ADDENDUM NO. 1

RE: Indiana University Bloomington
BL000B Multi-Building – BL057 Wylie and BL065 Optometry
Classroom Renovations

PROJECT No.: 20250503

DATE: March 20, 2026

H201

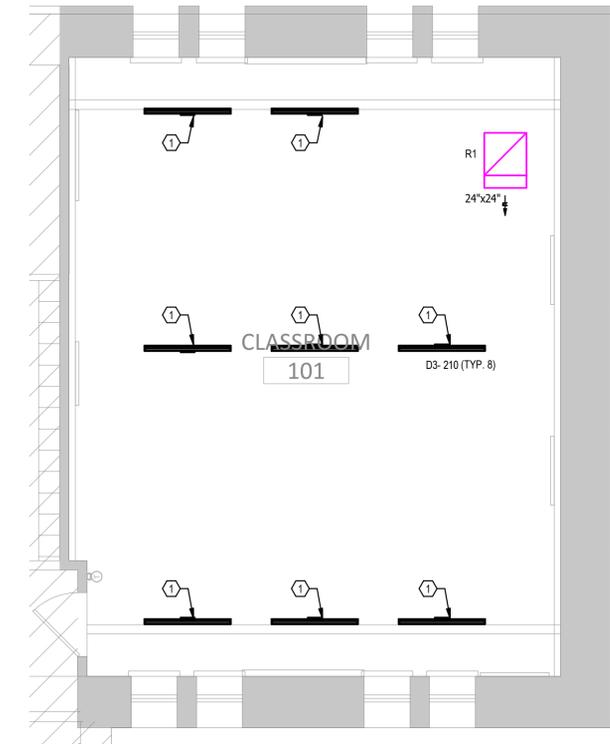
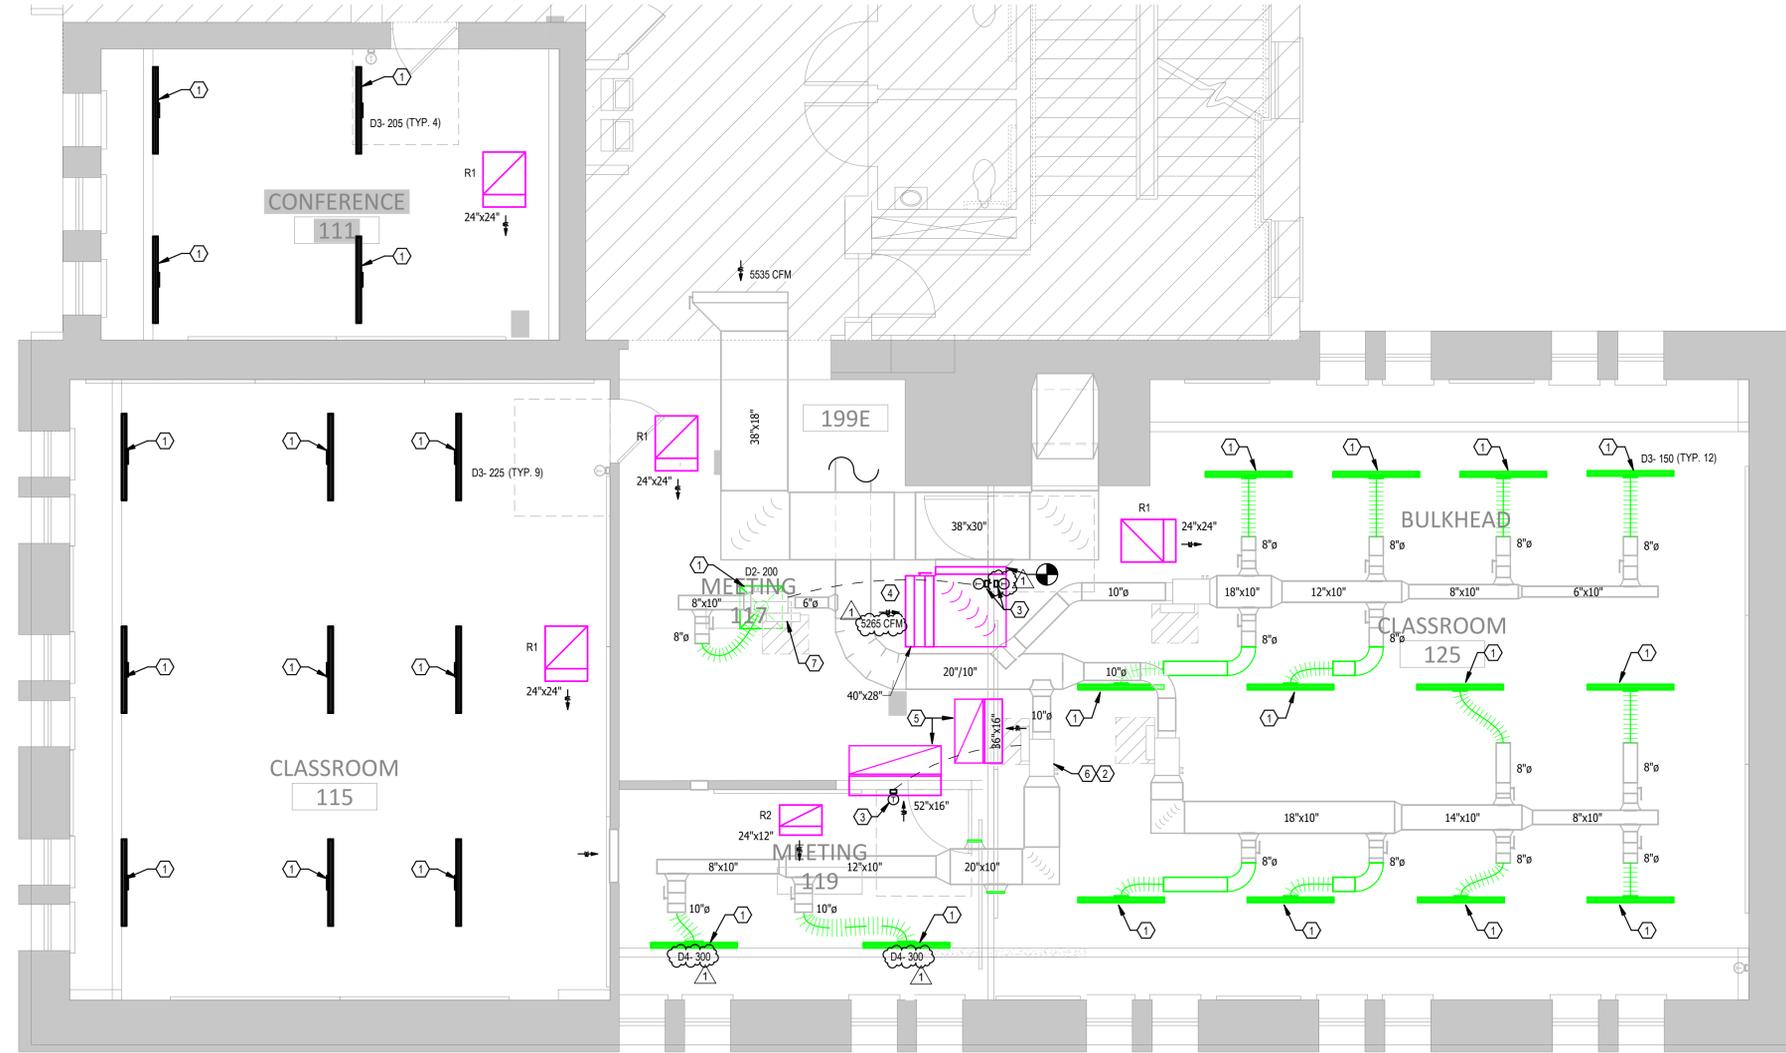
9. Sheet H200 – BL057 WYLIE HALL GROUND FLOOR HVAC PLANS
 - a. Revised plan notes.
10. H201- BL057 WYLIE HALL FIRST FLOOR HVAC PLANS
 - a. Revised plan notes.

- b. Modified airflow to diffusers within “MEETING 119”.
 - c. Added airflow to return air plenum.
11. Sheet H801 – HVC SCHEDULES AND DETAILS
 - a. Modified neck/inlet size to “D3” and “D4” within “HVAC DIFFUSER/GRILLE SCHEDULE”

E001

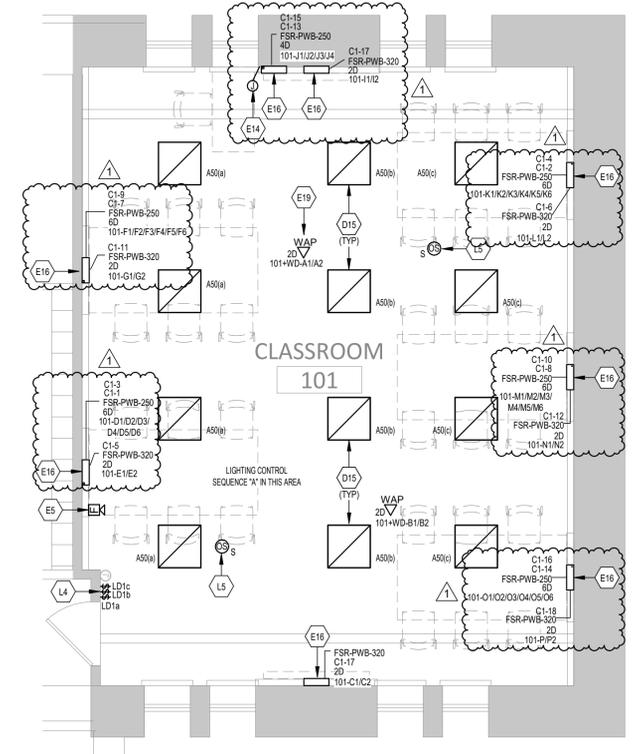
12. Sheet E001 – ELECTRICAL LEGEND
 - a. See attached plan for revised panel schedule for “C1”.
13. Sheet E201 – BL057 WYLIE HALL FIRST FLOOR ELECTRICAL PLANS

E201

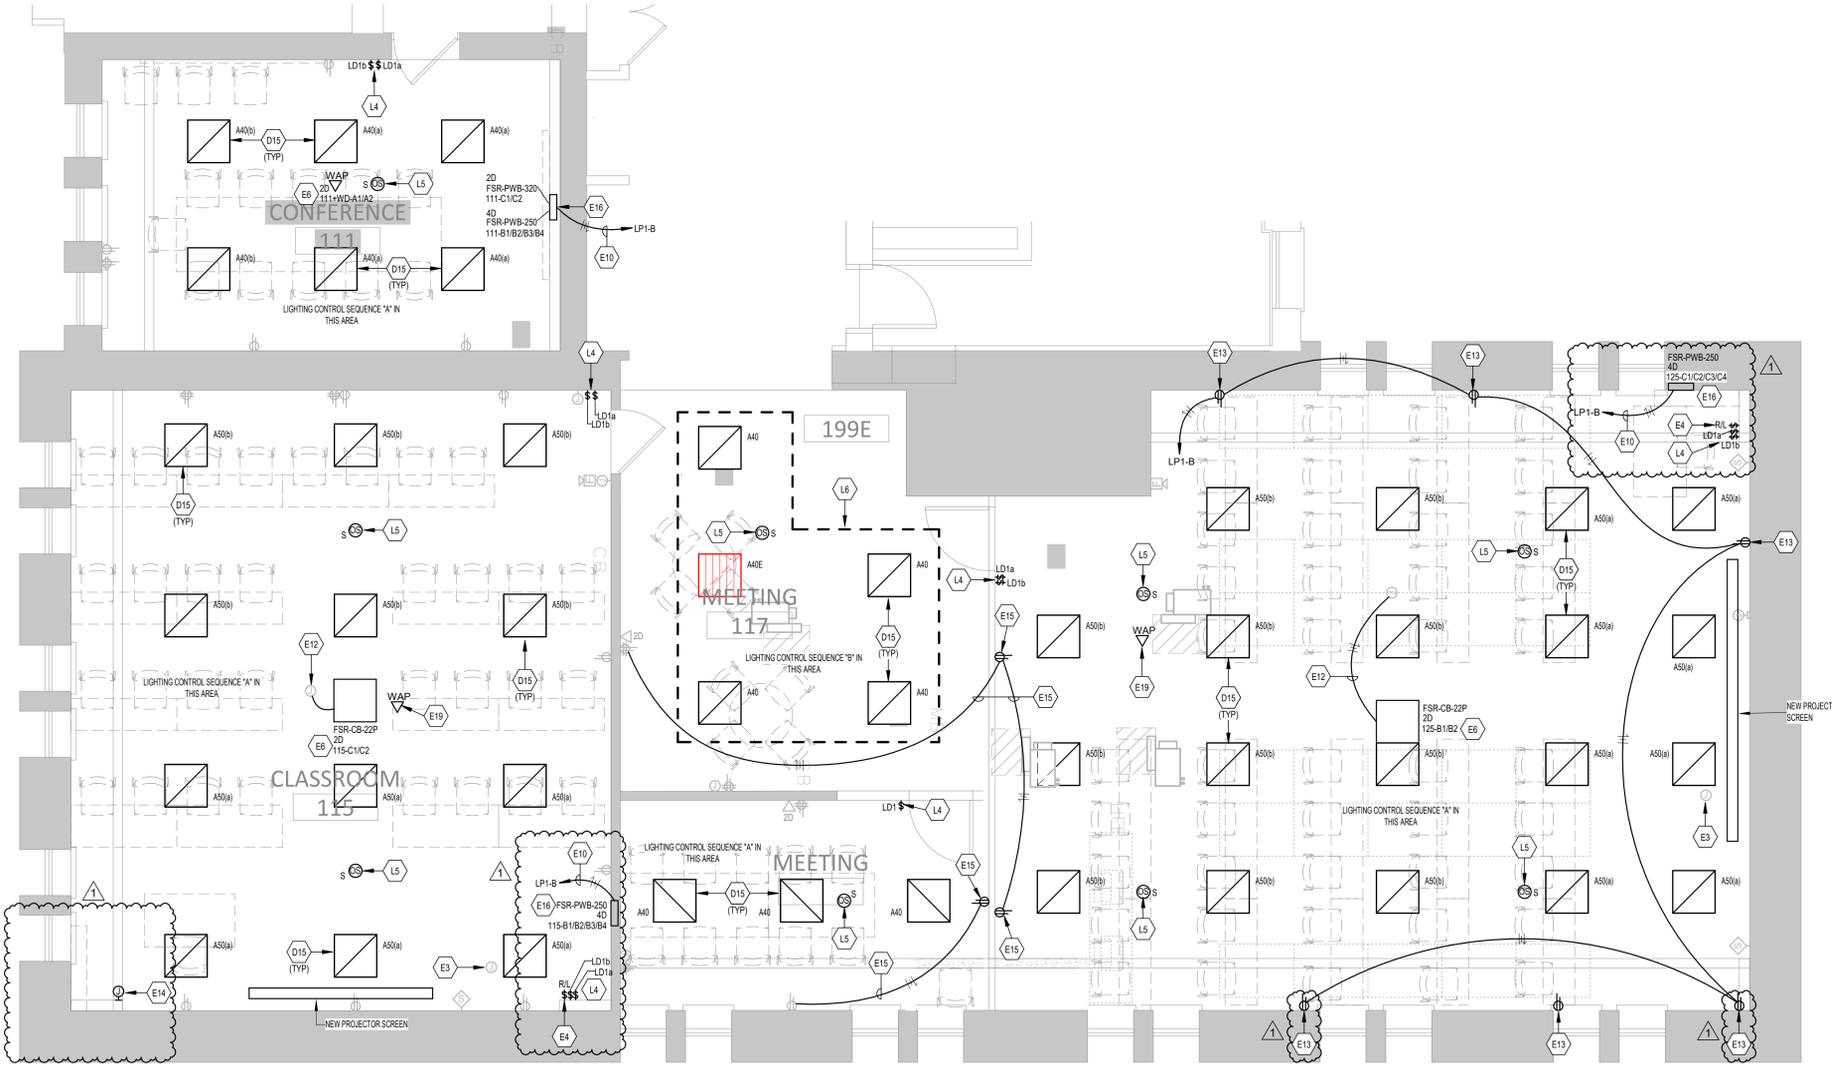
- a. See attached plan for revised circuit connections for devices indicated.
 - b. See revised tagged note #E13.
14. Sheet E400 – ELECTRICAL DETAILS – CLASSROOM A/V

4 FSR-PWB-320/250 INSTALLATION DETAIL
NO SCALE

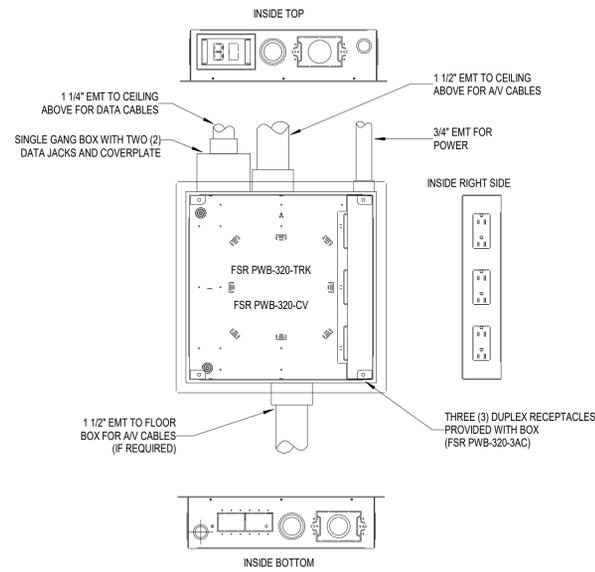
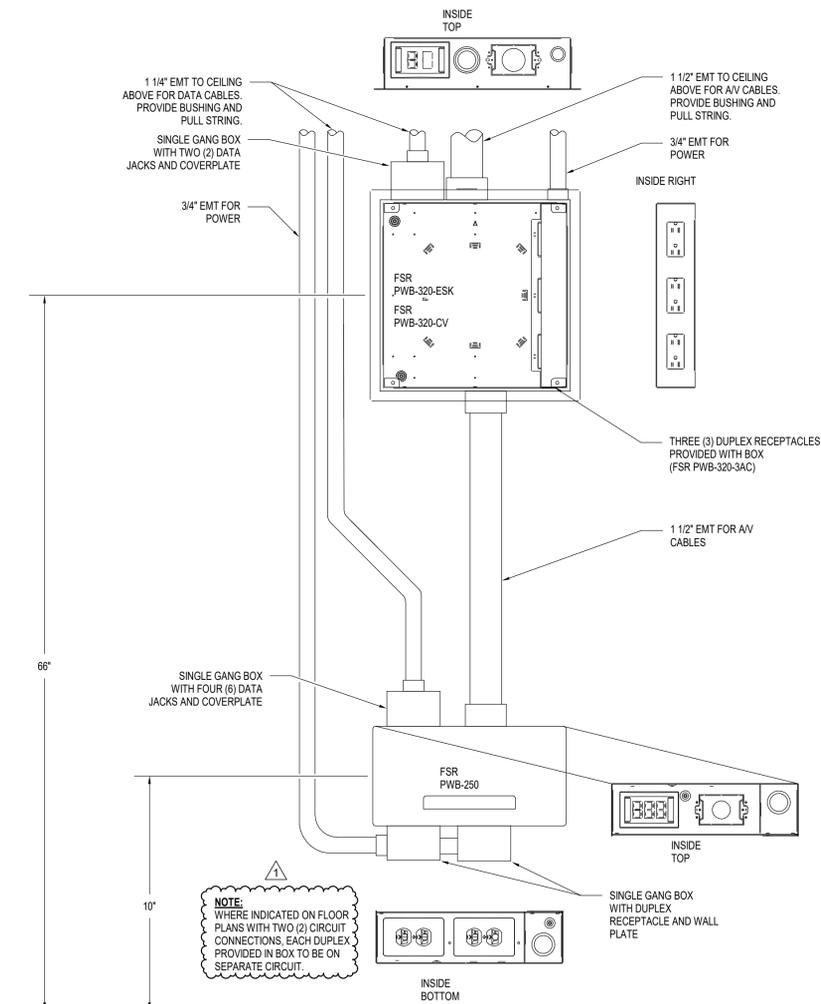
- a. See attached plan for revised details #1 and #4.
